# **SOUTH FLORIDA WATER MANAGEMENT DISTRICT**

## **Memorandum**

**Subject:** Investigation of Complaints Re: ERP Permit for Sierra Ranch - Project # 24-07

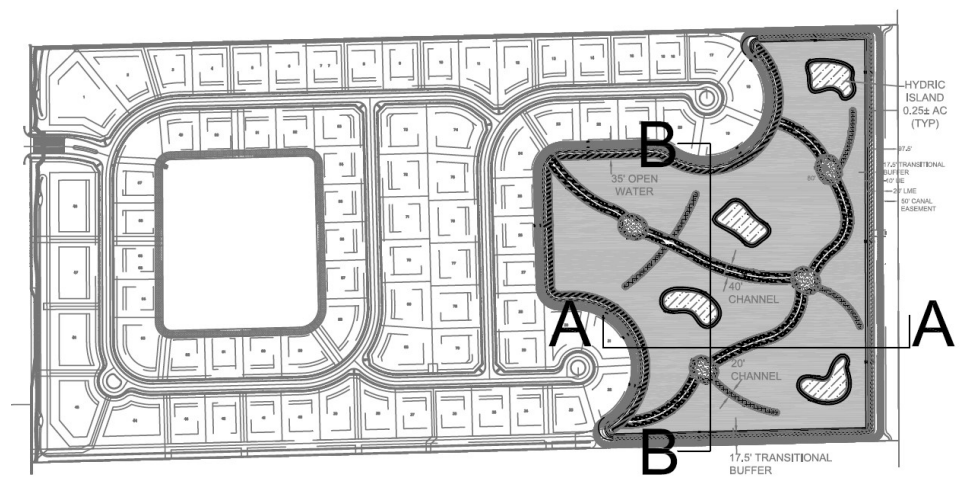
To address the allegation as to whether the design contains conflicting cross-sections regarding the open water channel (with one showing a 7-foot depth and another a 10-foot depth) we compared the indicated elevation shown on the Section B-B Typical Preserve Bank Section (shown below) to the elevations indicated on other typical drawings in the same set of plans. The drawings state that all elevations are shown in **NGVD 1929 DATUM**.

The above cross section shows the bottom of the open-water channel elevation at -4.6 feet and the Control Water Elevation at +2.4 feet. Based to this cross section, the bottom of the open water channel was designed to be 7 feet below the Control Water Elevation. The design documents also contained the following drawing. (The A & B cross-sections are shown on the following page.)

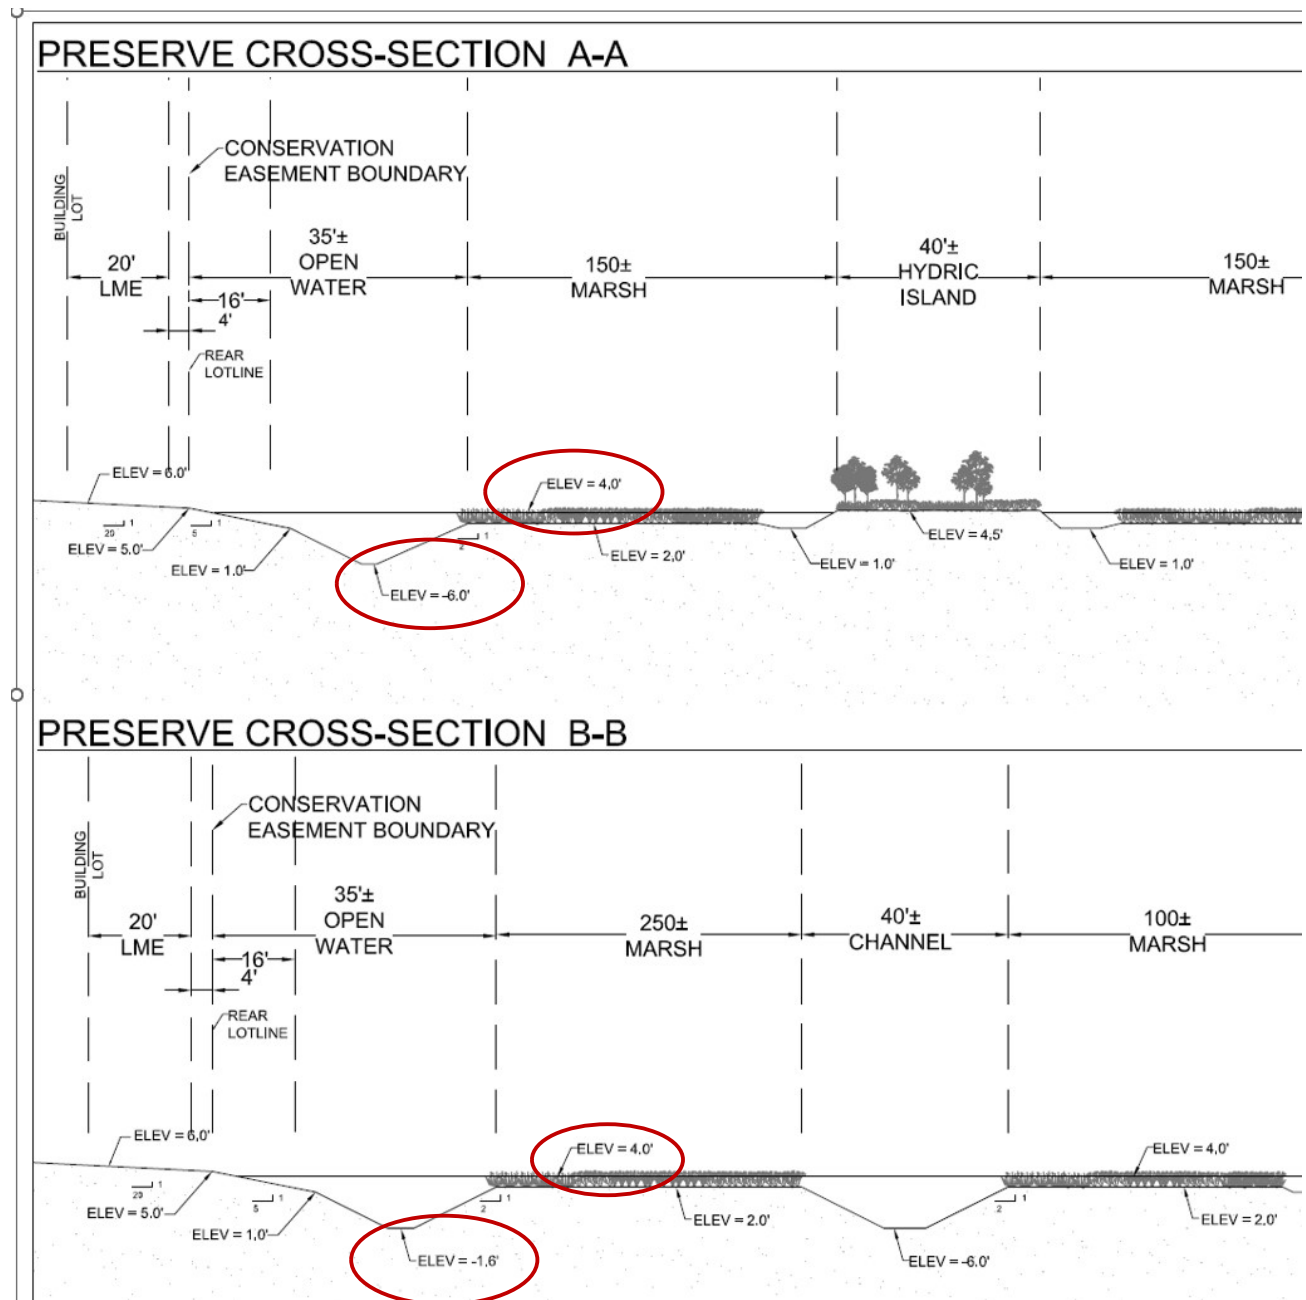
The Preserve Cross-Section A-A above shows the open water channel elevation at -6.0 feet and a line that appears to be the Control Water Elevation at +4.0 feet; thus, indicating a designed water depth of 10 feet. Additionally, the Preserve Cross-Section B-B above shows the open-water channel elevation at -1.6 feet and a line that appears to be the Control Water Elevation at +4.0 feet; thus, indicating a designed water depth of 5.6 feet.

The line presumed to be the Control Water Elevations on both of the “Preserve Cross-Section” on page 8 are not labeled and may represent something else; therefore, we cannot definitively determine whether the differences between the drawings represents discrepancies. The as-built plans show the open-water channel was constructed with a base elevation of -4.6 feet NGVD, which is consistent with the cross section shown on page 7. Considering that the Control Water Elevations are not labeled on the apparent conflicting drawings there is insufficient evidence to prove or disprove this allegation; thus, the allegation is Not Sustained.

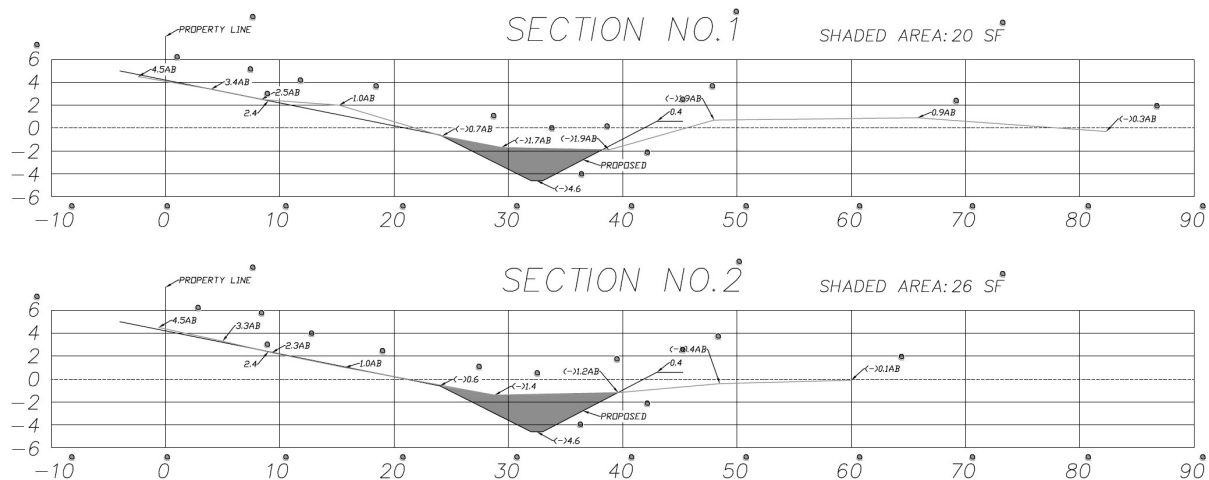
Our observations of the dates on the as-built surveys submitted to the SFWMD and the CBWCD confirm the Complainant's allegation and appears to be identical in every way, except for the sign-off date. The Complainant also requested their Consultant to review the two sets of plans to determine if they were identical. An email from the Consultant to the Complainant, dated October 24, 2023, states: "I checked the as-builts and they are indeed the same. The field work for the as-builts was completed on 12/01/2021. All survey's list either the last date of field work or the day that field work was completed. It is note 3 on the cover of the as-builts (see below). The dates of which the survey is signed does not signify that they rechecked the work."

Evidence supports the allegation that the survey field work was not updated between the as-built's submitted to the SFWMD and the CBWCD; thus, the allegation is Sustained.
